RE: PROPOSED RESIDENTIAL DEVELOPMENT, 128 HERRING ROAD, MACQUARIE PARK

As requested, we are writing regarding traffic and parking matters raised by Ryde Council, the Department of Planning, RTA and Department of Transport in relation to the above development. We have previously prepared a report¹ which was submitted with the Part 3A application.

In an undated memorandum, and letters dated 28 July, 21 June and 25 June respectively, Council, Department of Planning, Department of Transport and the RTA have raised a number of matters. These matters, and our responses, are set out below.

Figure 4.1: MPCPM Zone System

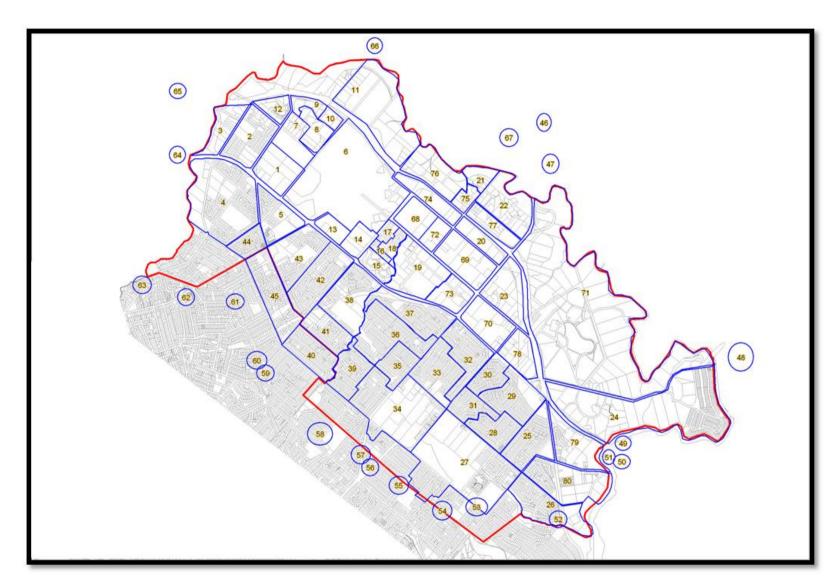
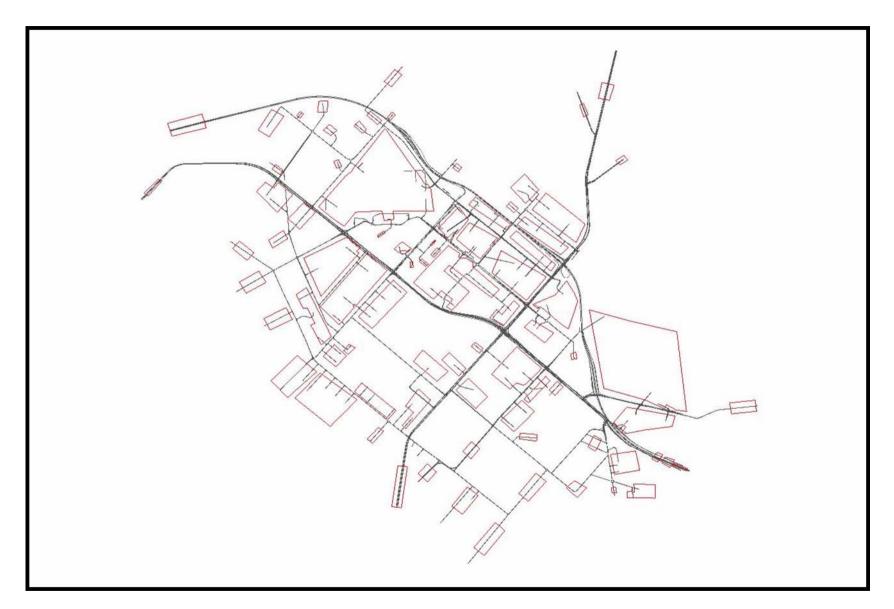
8. Consideration has been given to the Macquarie Park 2007 Base Paramics Model by using a first principles approach instead of building the development activity into the model and running the model to assess the 'with development' traffic impacts and accounting for the accumulative operational and functional traffic impacts in the Macquarie Park Road network. The supporting information e.g. the existing zone 14 traffic survey and source of the traffic data from the Macquarie Park 2007 Base Paramics Model has not been provided, so it is not possible to verify the report results and conclusions. The developer/traffic consultant should provide the supporting traffic information. Council makes available the Macquarie Park 2007 Base Paramics Model to the developer/traffic consultant by the developer/traffic consultant making an application, agreeing to the conditions of use and paying the prescribed fees. No application has been received. The preference is that the developer/traffic consultant should complete the application, pay the fees for its use and undertake the traffic impact assessment 'with development' using the Paramics model provided by Council.

The Macquarie Park 2007 Base Paramics Model includes existing traffic estimated to be generated by "zone 14", which is identified in Figures 4.1 and 4.2 of the Macquarie Park Paramics Model User Manual (Reference Document No. 2) (on Council' website, copies attached) as existing development with access from the western side of Herring Road, between Epping Road and Waterloo Road. We have counted the morning and afternoon traffic generation of the existing development on the western side of Herring Road, which includes zone 14 development, as well as some zone 6 development on the Macquarie University site. These surveys found existing traffic generations of some 210 and 150 vehicles per hour two-way during morning and afternoon peak hours respectively. As these generations include some development in zone 6, they are an over-estimate of traffic for zone 14.

With the additional traffic from the proposed development, of some 160 vehicles per hour two-way, traffic generation of the zone 14 land uses would be some 370 and 310 vehicles per hour two-way during morning and afternoon peak hours respectively.

The consultant assisting Macquarie University has advised that the Macquarie Park 2007 Base Paramics Model includes traffic generation from zone 14 of some 480 and 500

vehicles per hour two-way during morning and afternoon peak hours respectively. Therefore, the Paramics model has been based on a higher generation than existing plus development flows. The proposed development traffic has therefore been included in the current Paramics modelling.
